# Product Change Notification

<b>Change Description:</b>	Honeywell HOA1887 end-of-life replacement
<b>Motor(s) Affected:</b>	Driver Designer's Kits
<b>Customer Classification Level(s)*:</b>	1

<b>Date of Implementation:</b>	7/20/2022
<b>ECN #, RMA, MRR, or unique #:</b>	ECN 56387

## FORM

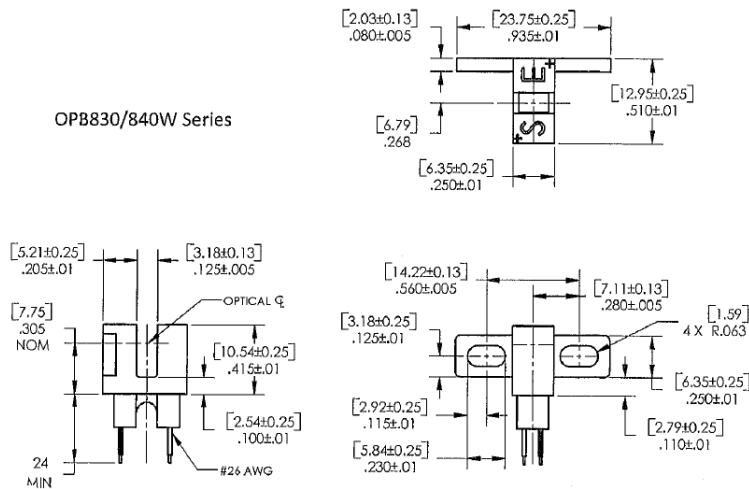
Honeywell HOA1887 is no longer available from the manufacturer, we must source a replacement. Supplier recommended TT Electronic OPB841W51Z slotted optical switch, we have conducted testing regarding its form, fit, and function and determined it is a suitable drop-in replacement. There is no risk with using the new optical switch OPB841W51Z in place of HOA1887. A limited quantity is available as last-buy upon request.

No risk to use OPB841W51Z as replacement for HOA1887, part is up-reved to new supplier and model number. A limited quantity is available as last-buy upon request. Please contact your sales representative or email at [pcna@linengineering.com](mailto:pcna@linengineering.com) for more information.
